14 September 2012

Subject: Allied Mills Concept Plan Application – Stormwater and Flooding Issues

Figure 1: HES-RAS Flood Model Cross Section Locations

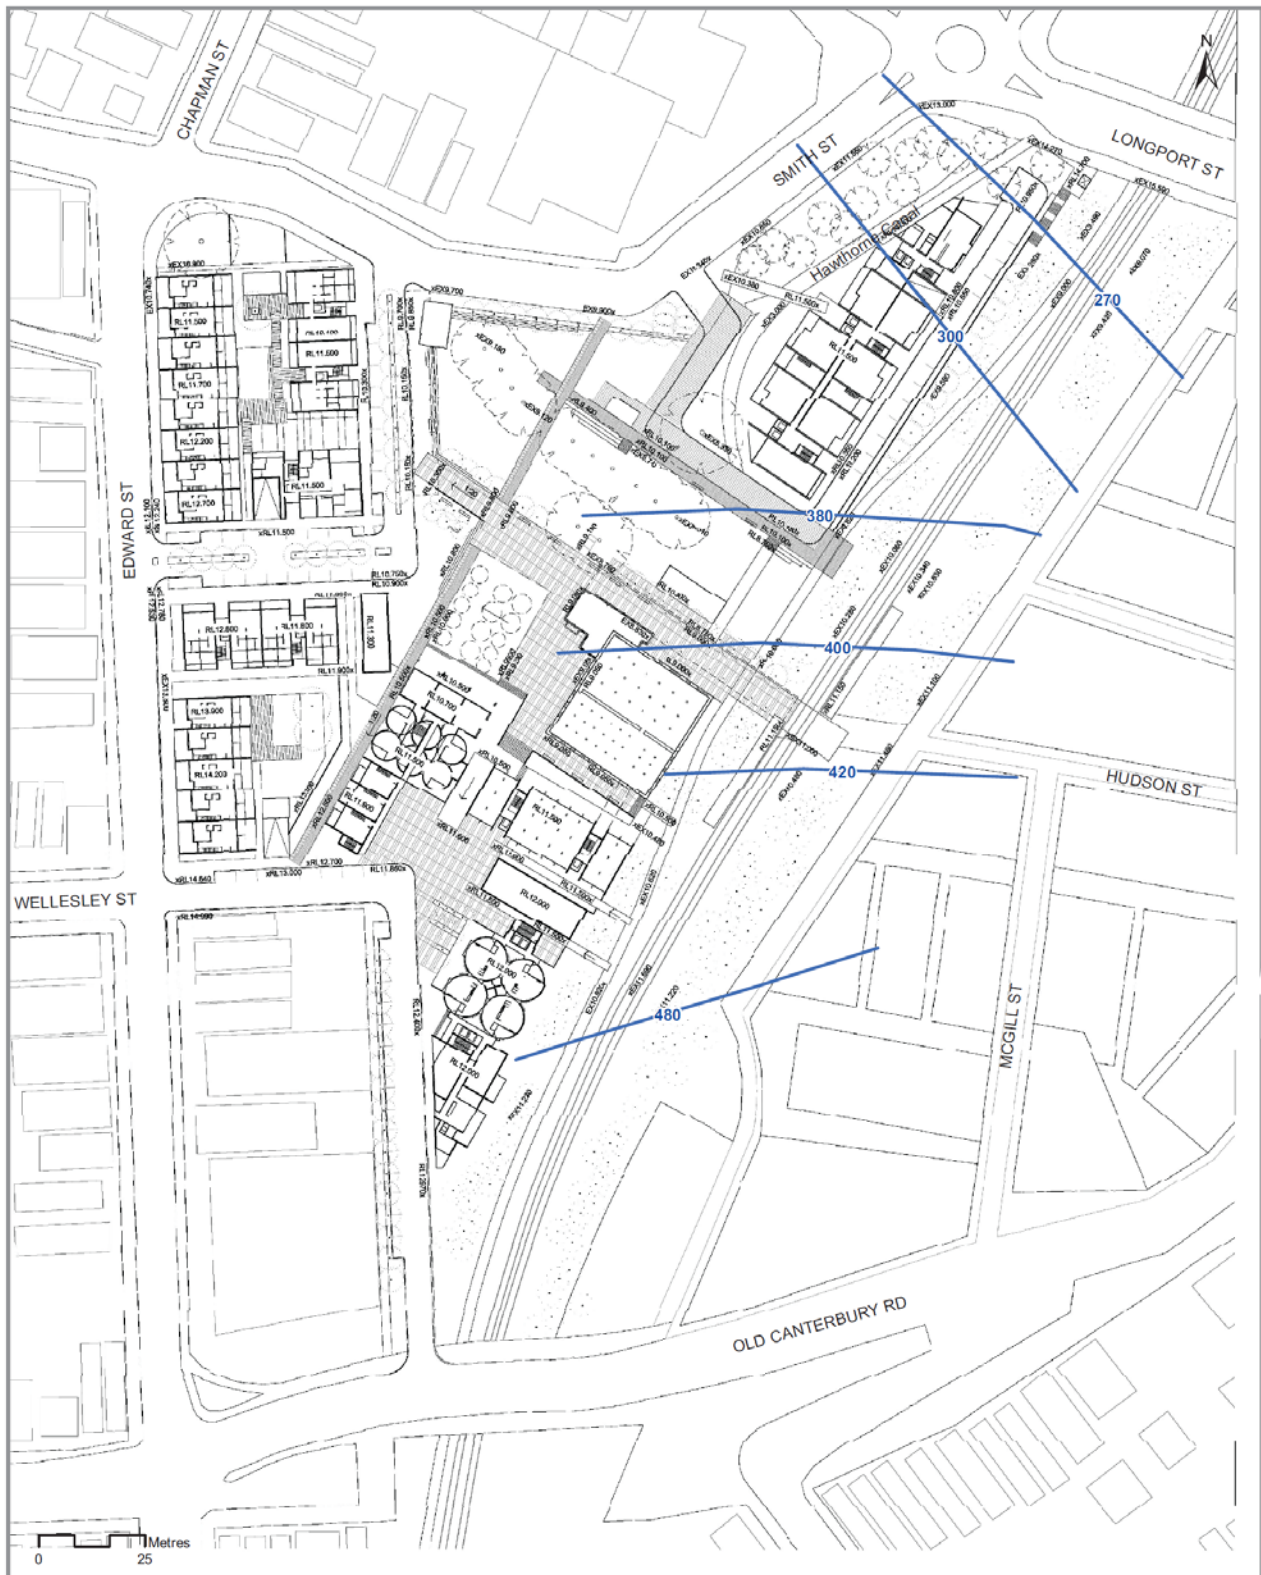
Table 1 summarises the estimated flood levels for these scenarios at various chainages in the HEC-RAS model (see **Figure 1** for locations).
